Planning and Zoning Commission AGENDA

Monday, March 09, 2020

STAFF REPORT
KETCHUM PLANNING AND ZONING COMMISSION
REGULAR MEETING OF MARCH 9th, 2020

PROJECT:	4 th & Walnut Avenue Mixed-Use Building
FILE NUMBER:	P 20-024
APPLICATION TYPE:	Pre-Application Design Review
ARCHITECT:	Graham Whipple, Resin Architecture
PROPERTY OWNER:	Walnut & Fourth LLC (Representative: Ryan Kirkham)
REQUEST:	Pre-Application Design Review for the development of a new 27,316 square-foot, two-story mixed-use building
LOCATION:	371 & 391 N Walnut Avenue (Ketchum Townsite: Block 44: Lots 7 & 8)
ZONING:	Retail Core of the Community Core (CC-1)
REVIEWER:	Abby Rivin, Associate Planner

EAST FIFTH STREET

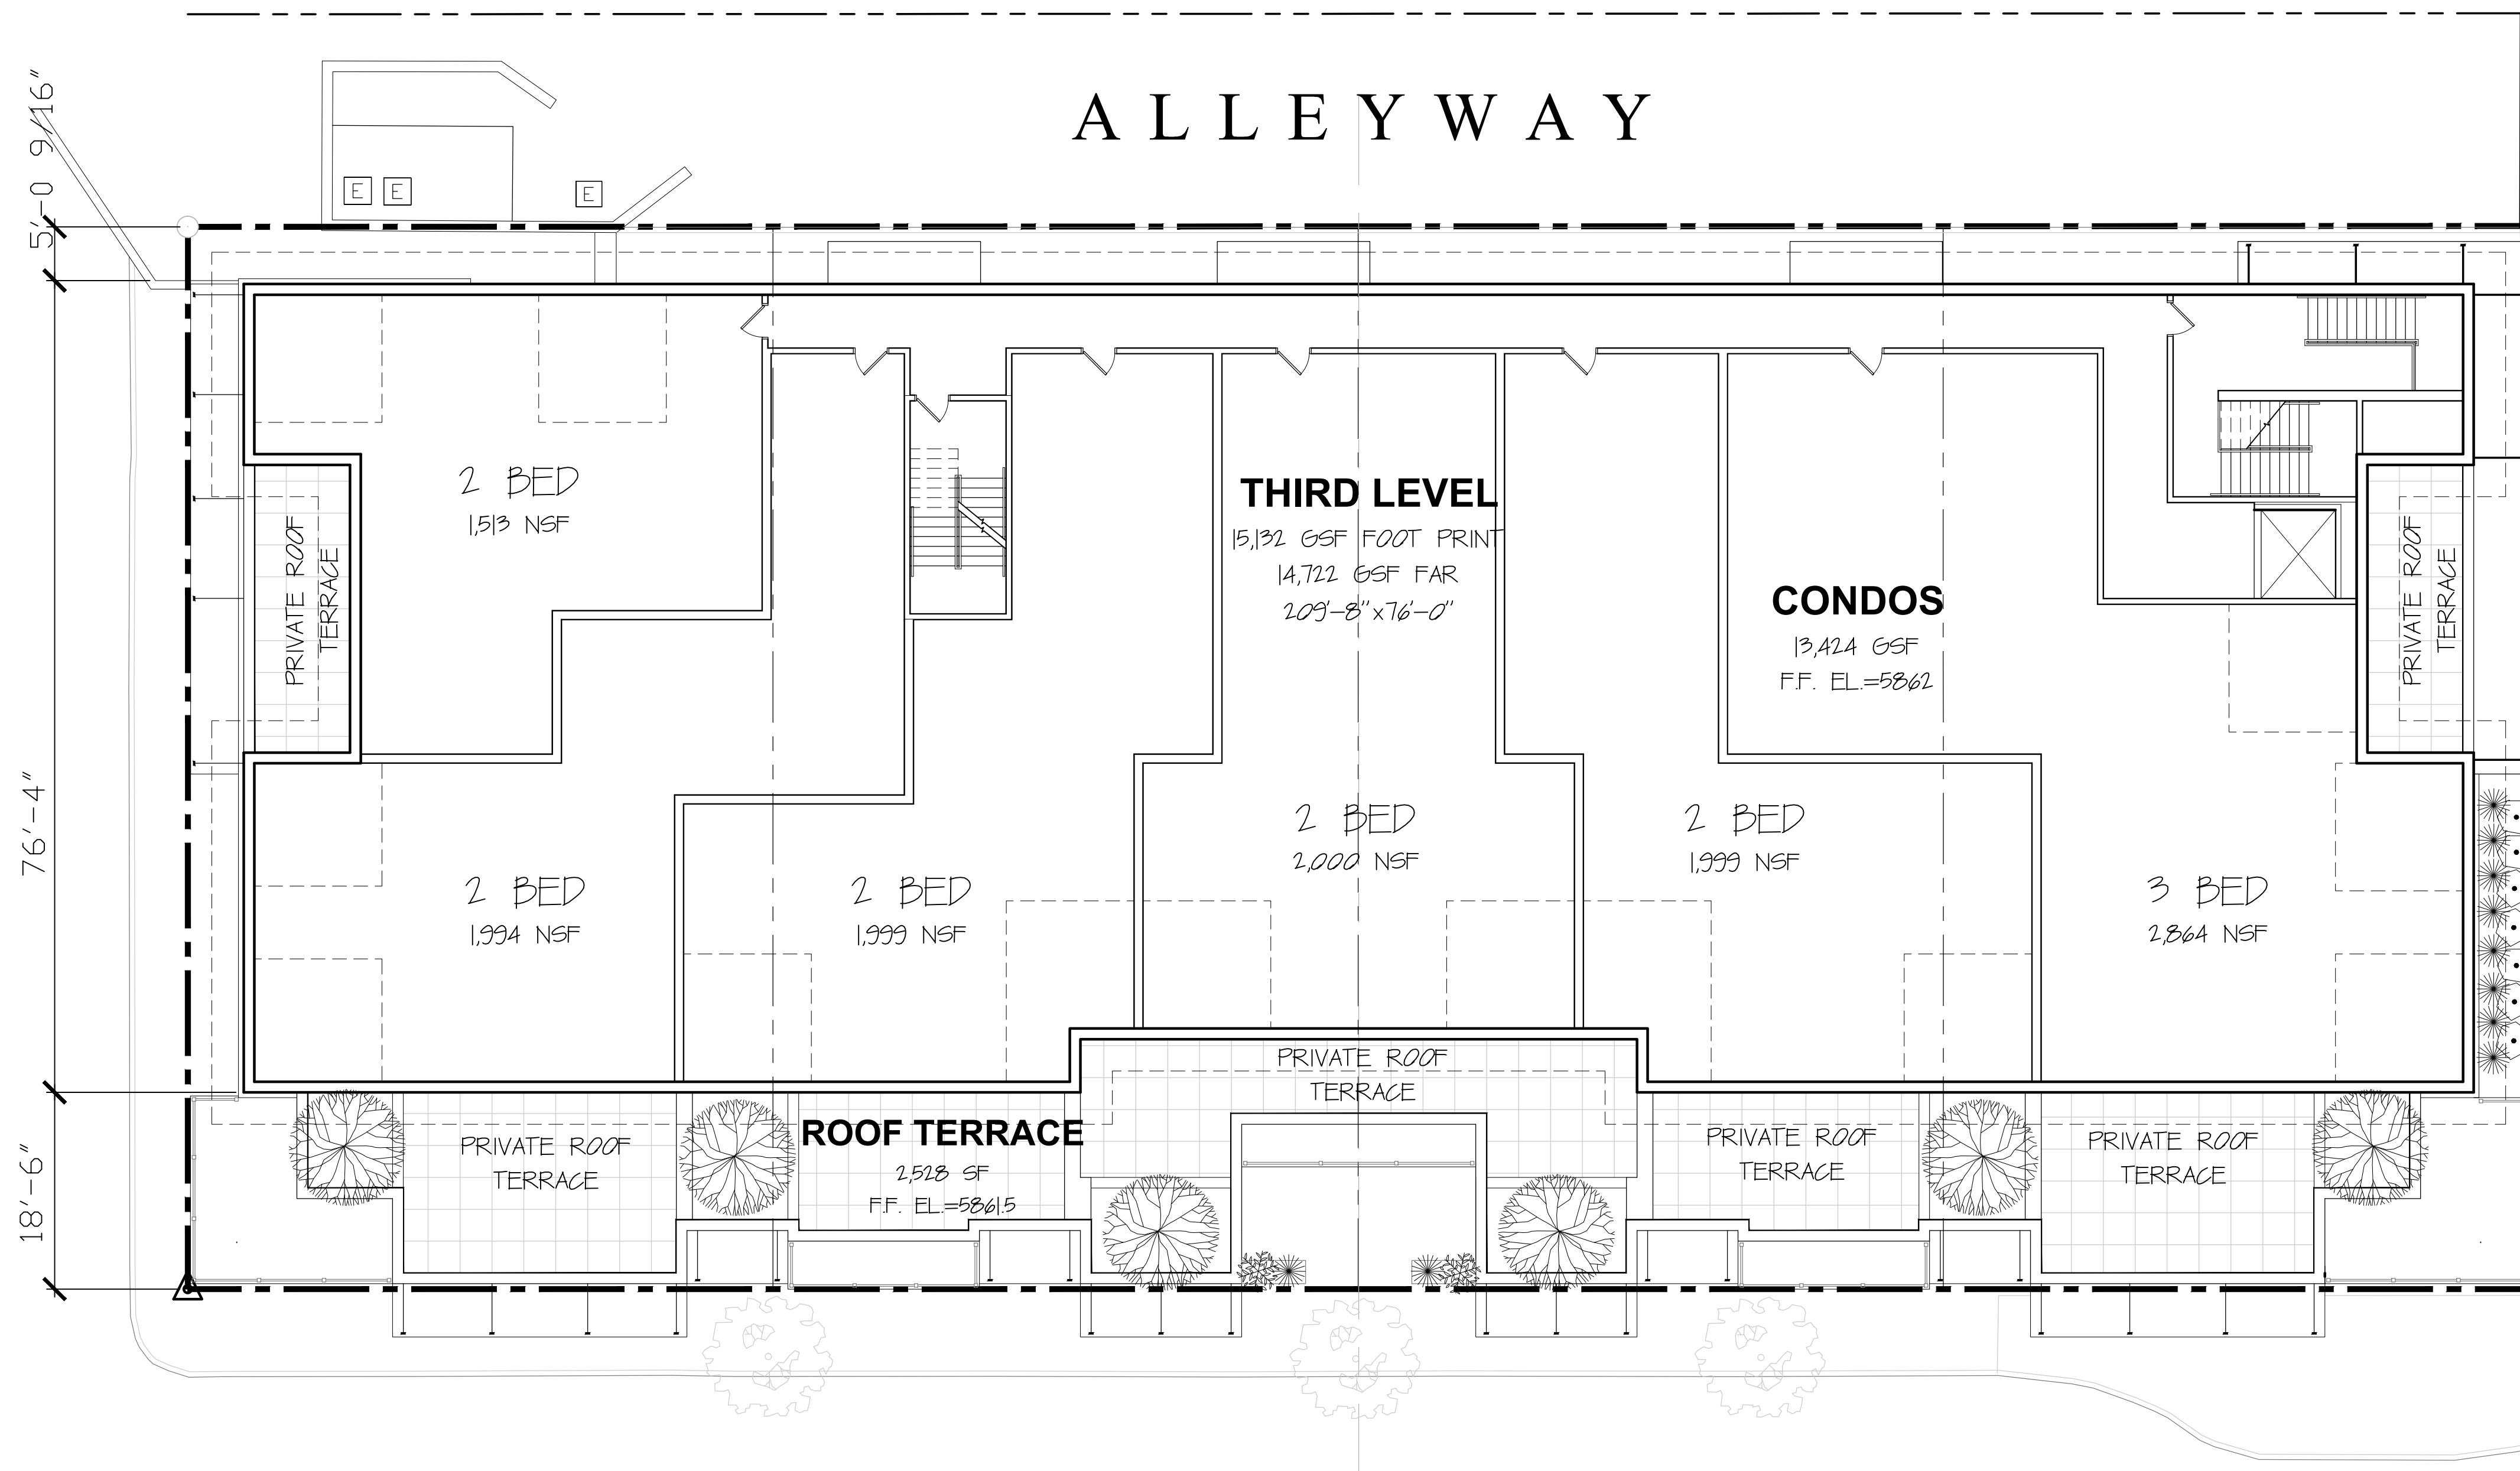
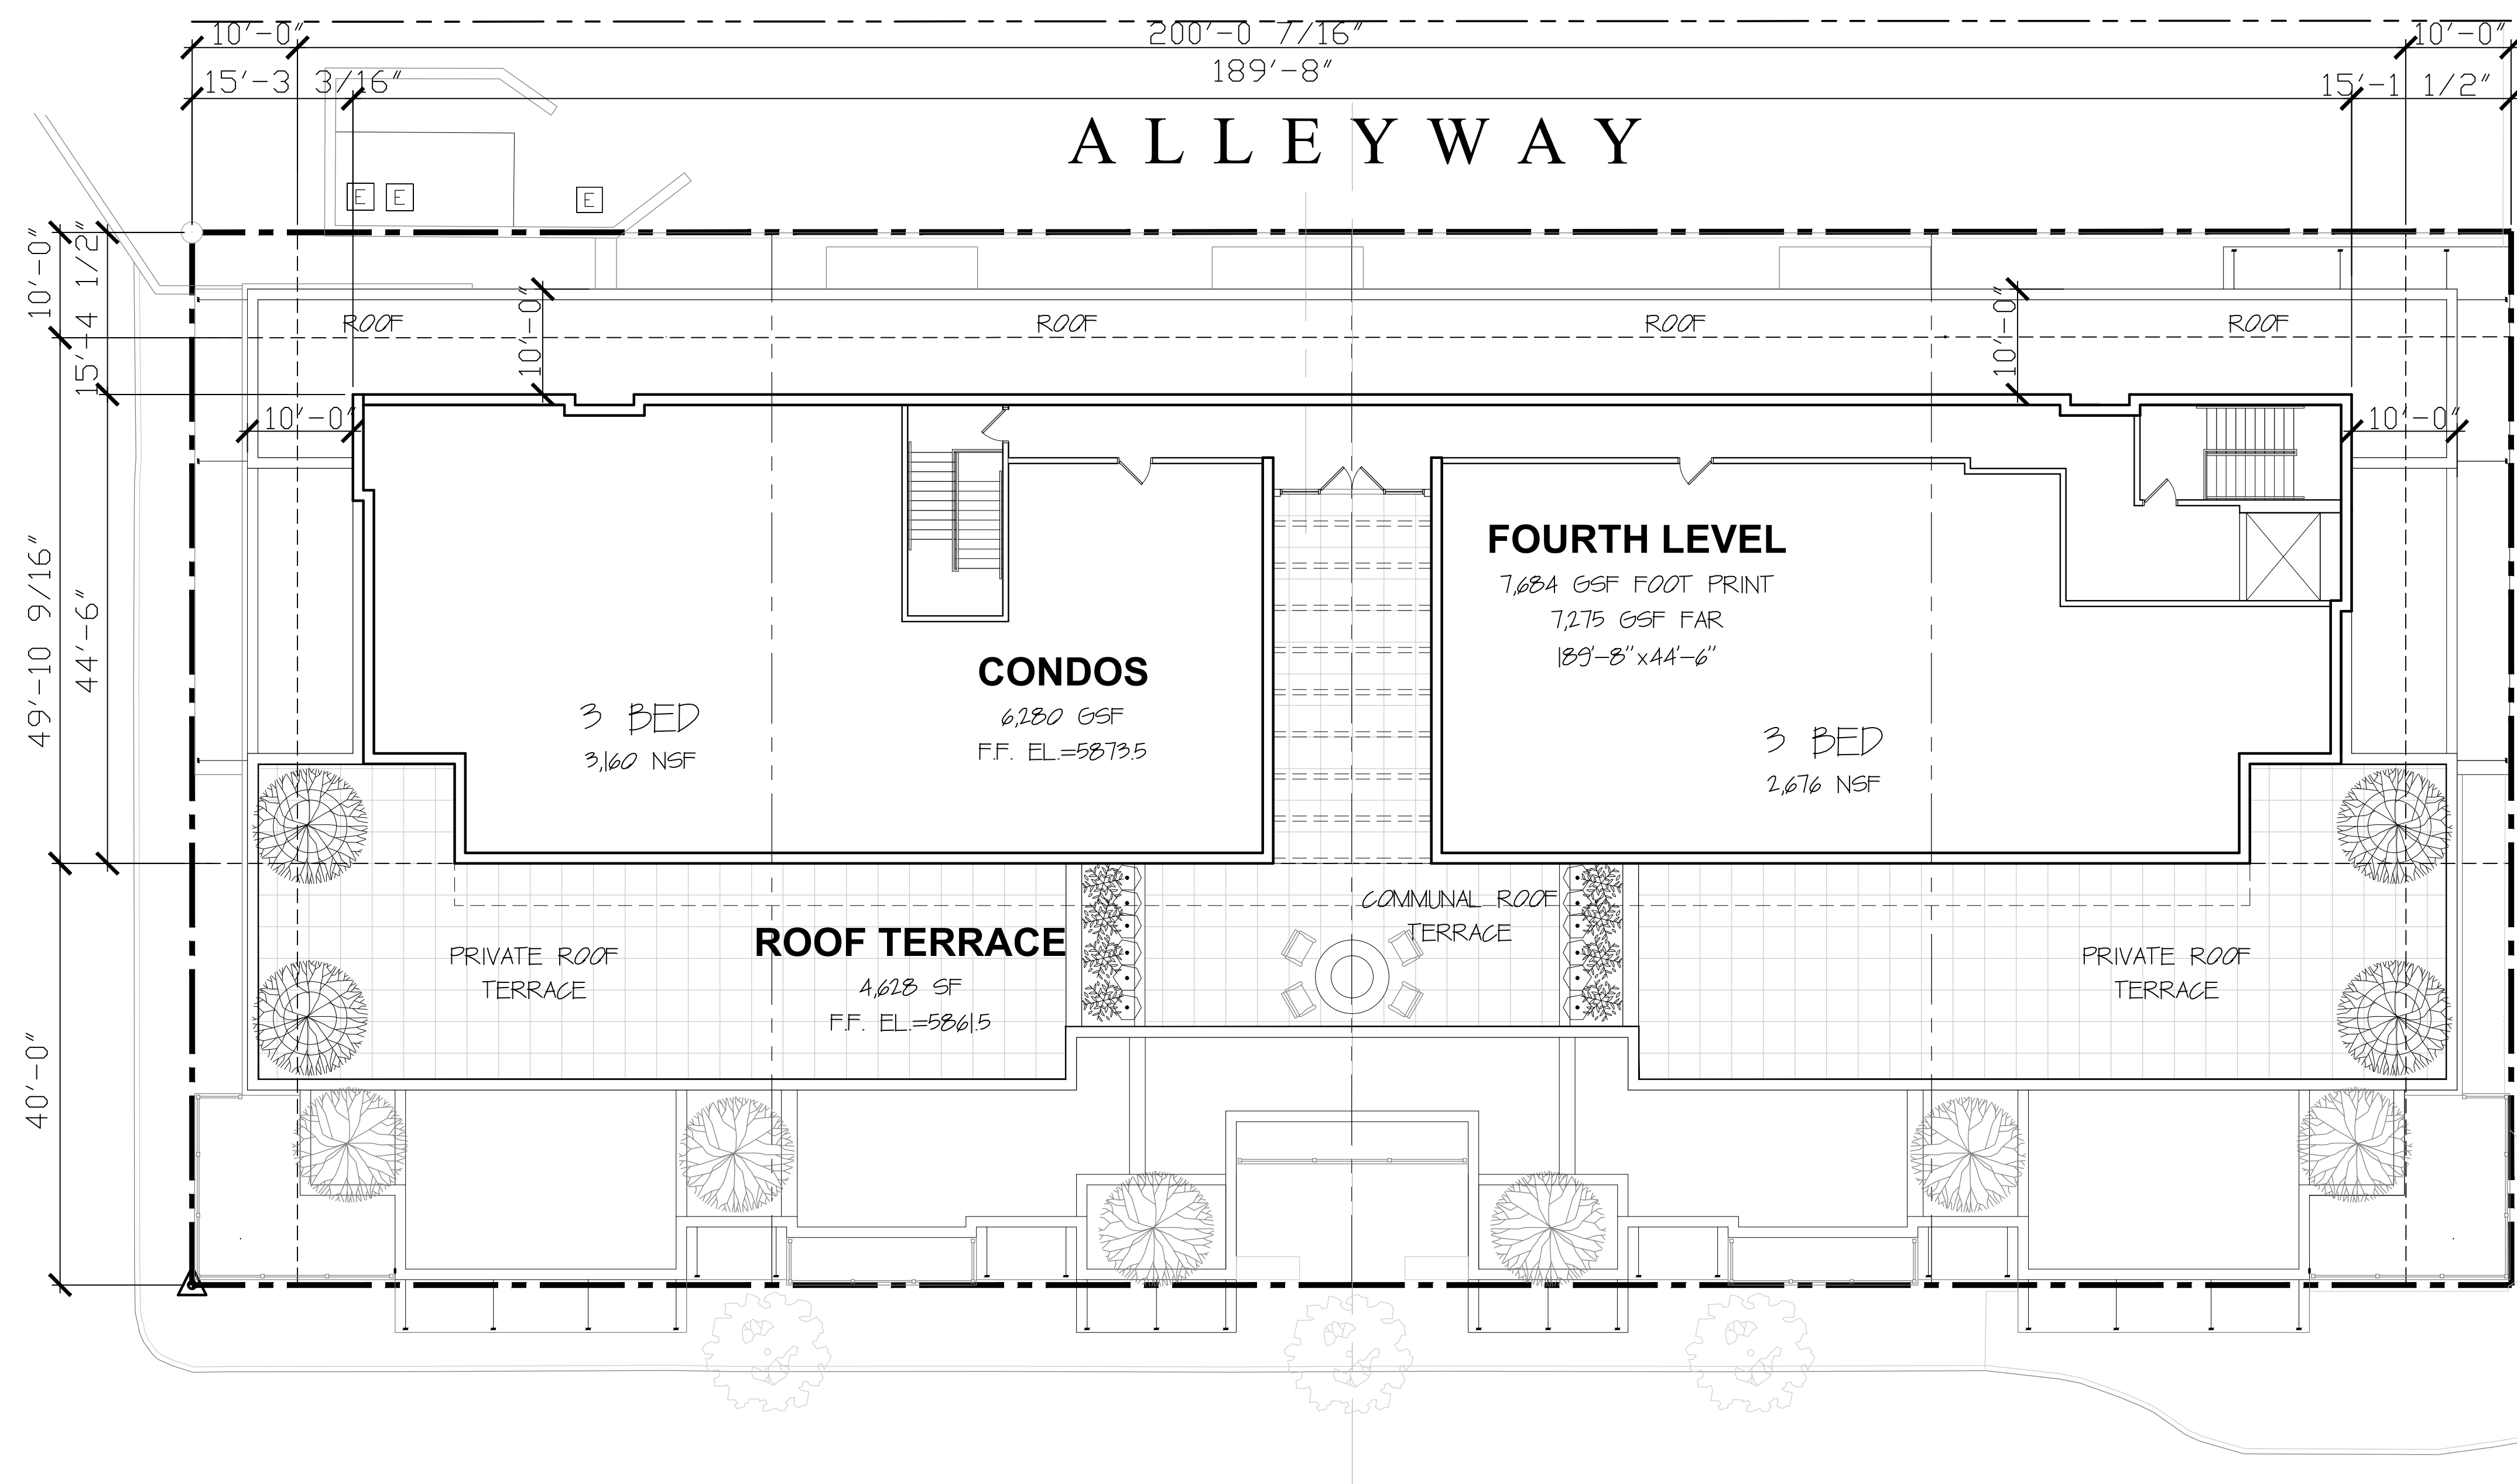
The floor plans on Sheets A1.0, A1.1, A1.2, and A1.3 don't show the location of window or door openings. The elevations indicate residential units with walls comprised entirely of windows. The building's outsides don't match its insides—the exterior of the building doesn't match the residential use proposed within the building. This discrepancy raises a concern that of the preliminary design drawings unrealistically depict the building's appearance.

Figure 1: Rendered Elevation, Project Plans: Sheet A5.1

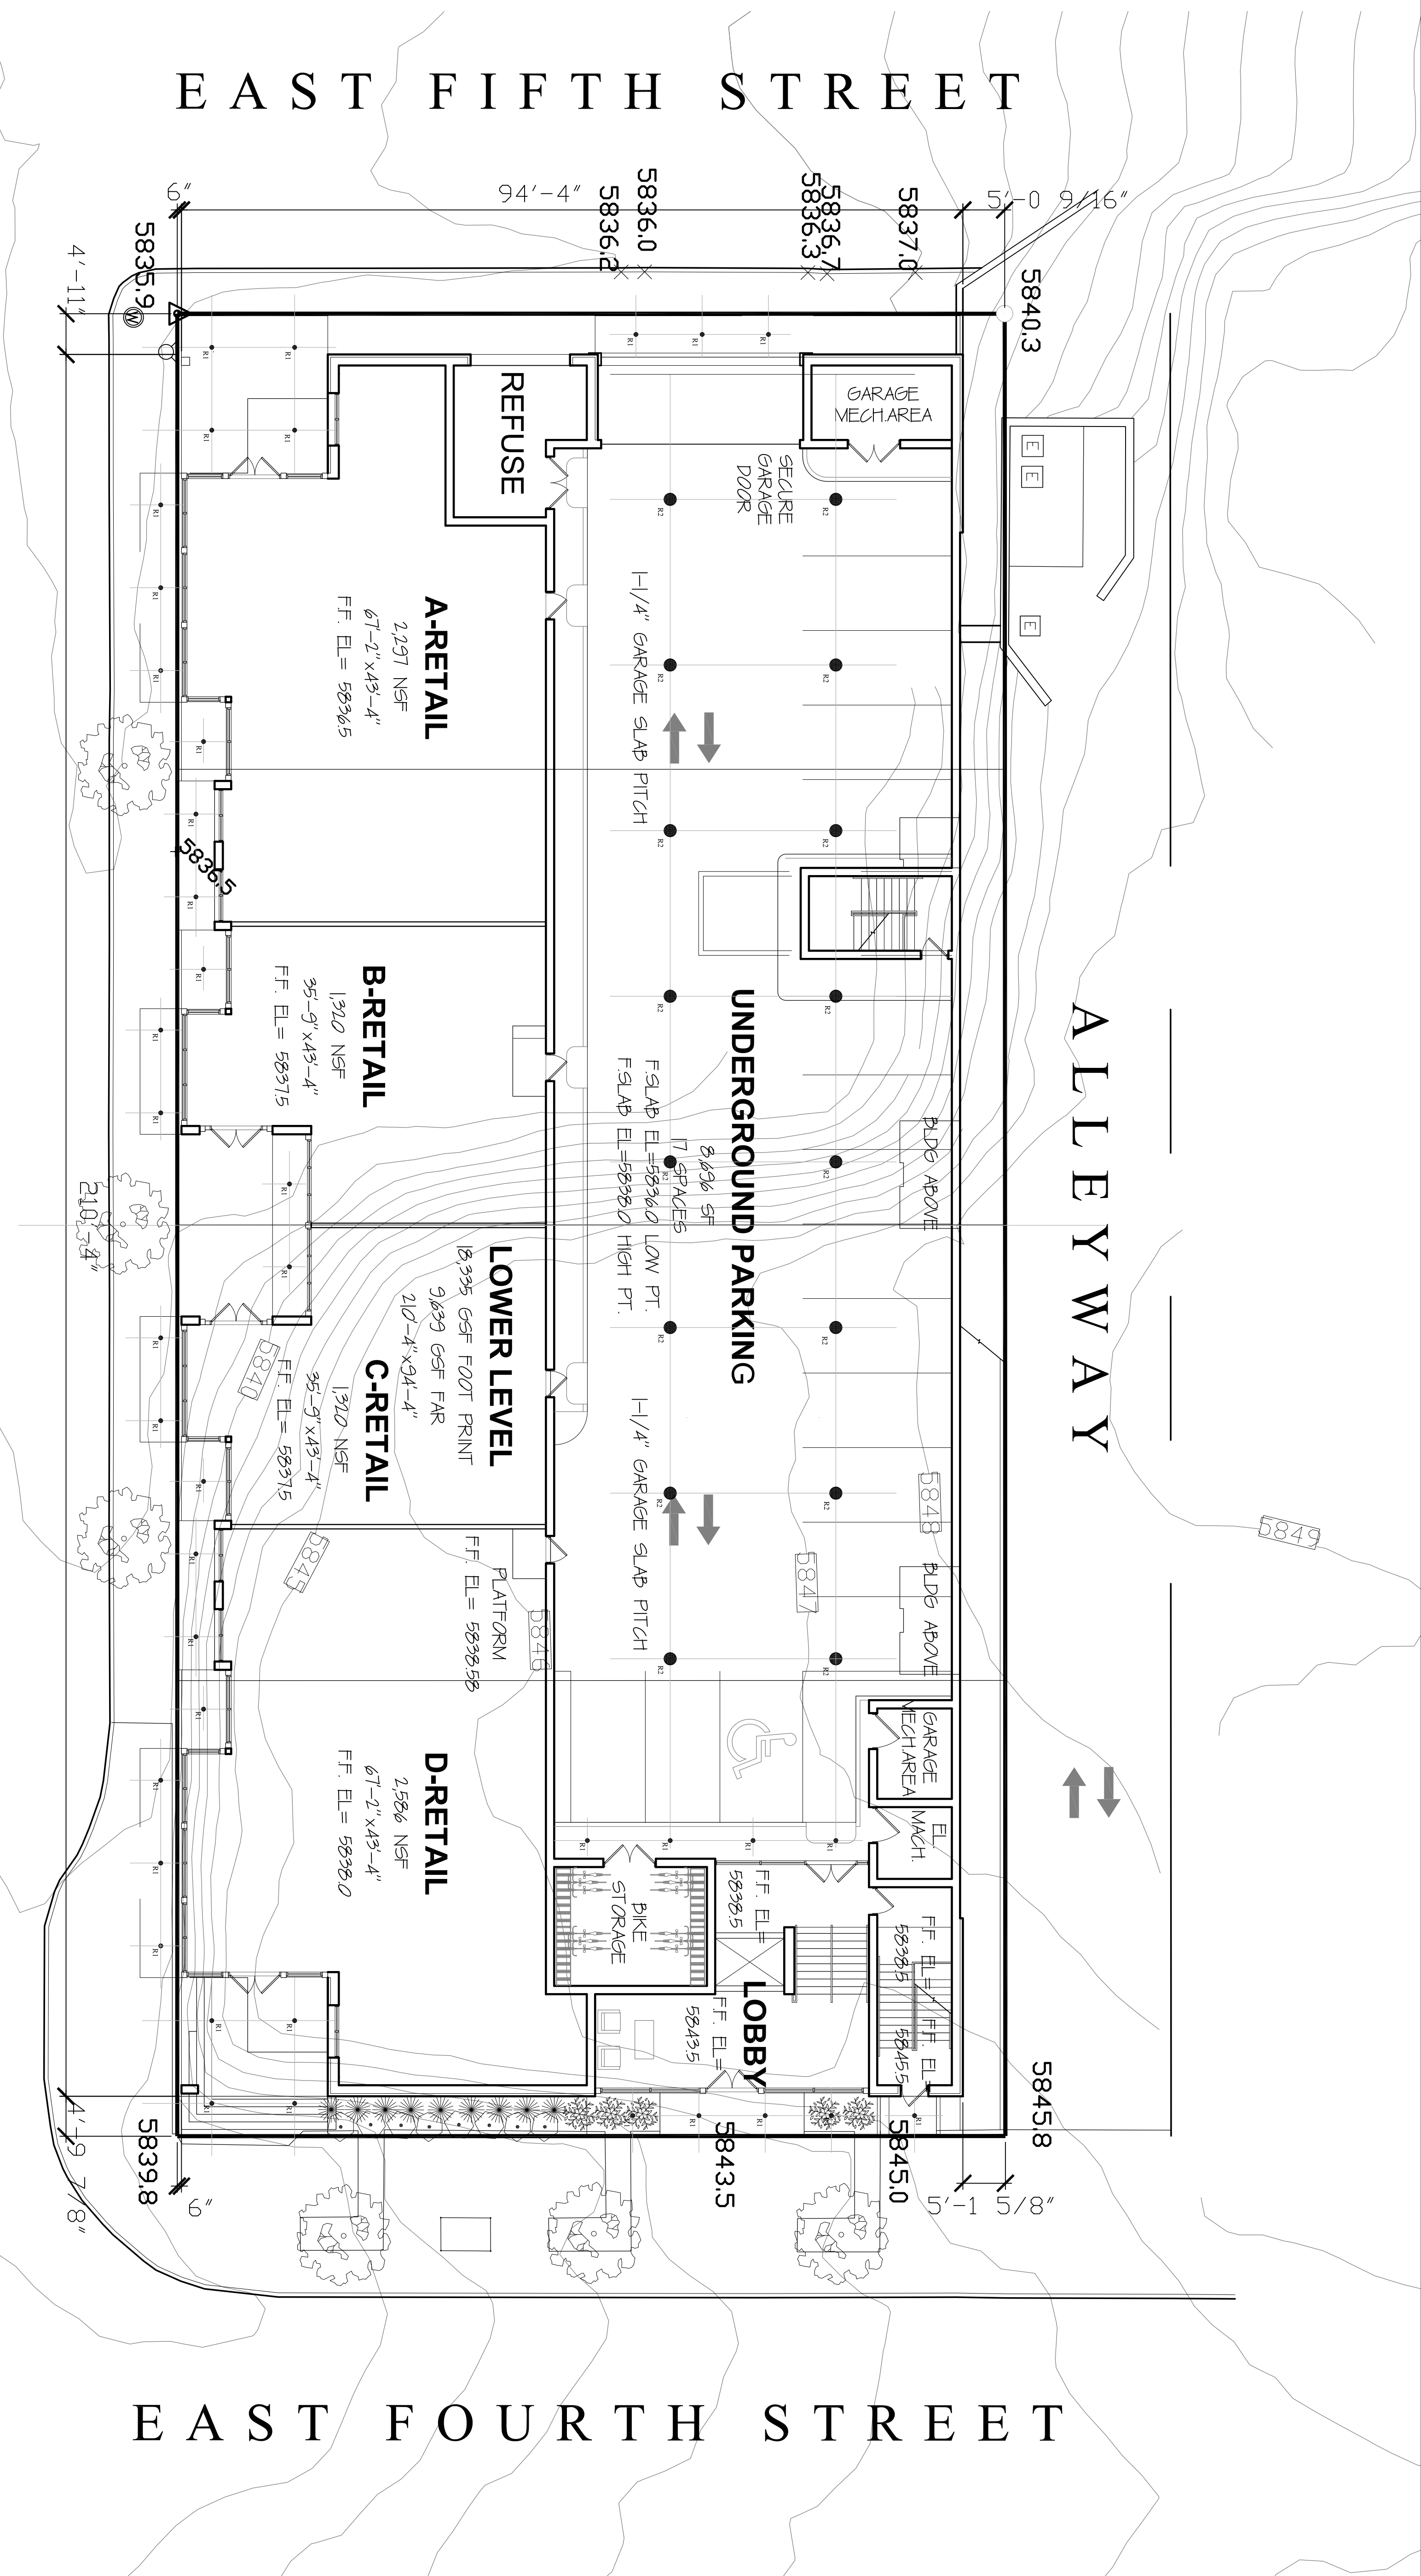
The rendering submitted with the Pre-Application (Sheet A5.0) is an unrealistic bird’s-eye view of the building. In order to ensure the proposed development maintains Ketchum’s mountain town character, the project plans must show the mixed-use building within the context of downtown Ketchum. The final Design Review application must include building renderings within the context of neighboring buildings and from multiple key vantage points throughout town. The renderings should represent realistic points-of-view to show the building’s relationship to Main Street and with the existing development in downtown Ketchum.
